Hope Creek Generating Station  
Job 10855  
Reactor Feed Pump Turbine Steam  
P&ID 10855M-31-1, Sheet 2, Revision 2

PUBLIC SERVICE ELECTRIC AND GAS COMPANY  
HOPE CREEK GENERATING STATION

P&ID  
REACTOR FEED PUMP  
TURBINE STEAM SYSTEM

JOB NO. 10855 DRAWING NO. M-31-1-SHT-2 2

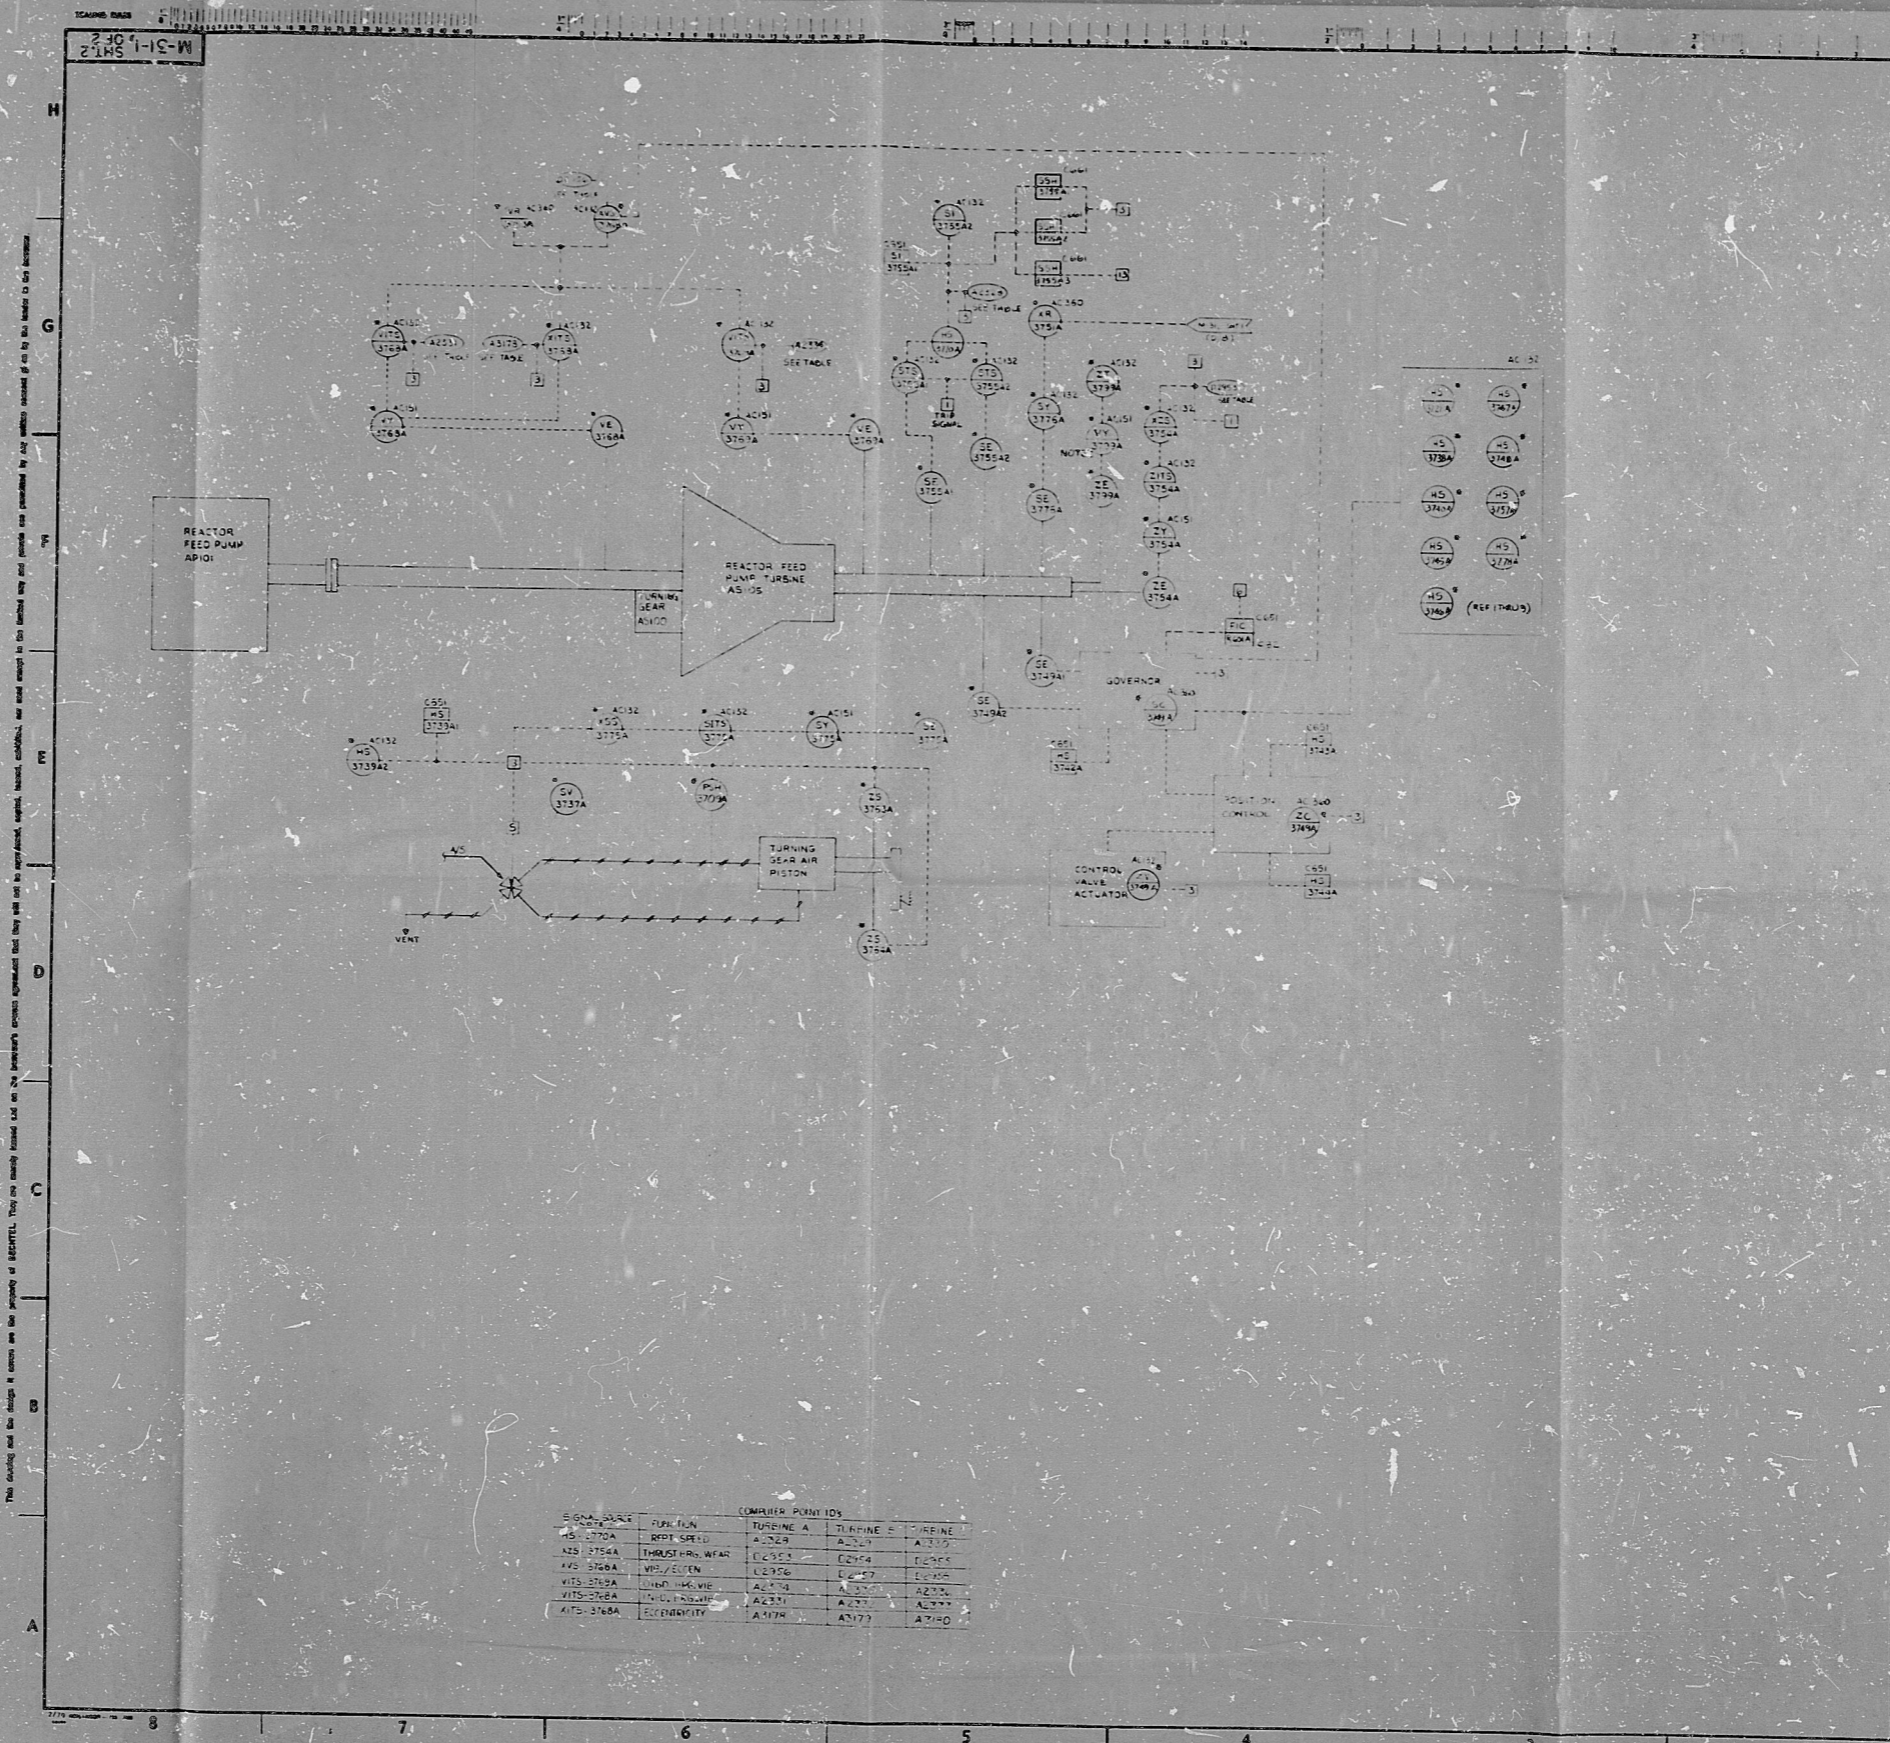
Coordinator	Revisions
A-4	Added the signal source column in the computer points ID's valuation.
E-4	Changed 2Y-3749A as pointed in AC132.
F-4	Changed 3Y-3776A to 3Y-3775A as indicated by the vendor.
F-4	Shown 3Y-3762A as pointed in control room panel C851.
G-4	Shown electrical connections computer points logic originating from 3Y-3754A in lieu of 3Y-3764A.
G-4	Shown electrical signal to 3Y-3751A originating from 3Y-3751, Sheet 1.
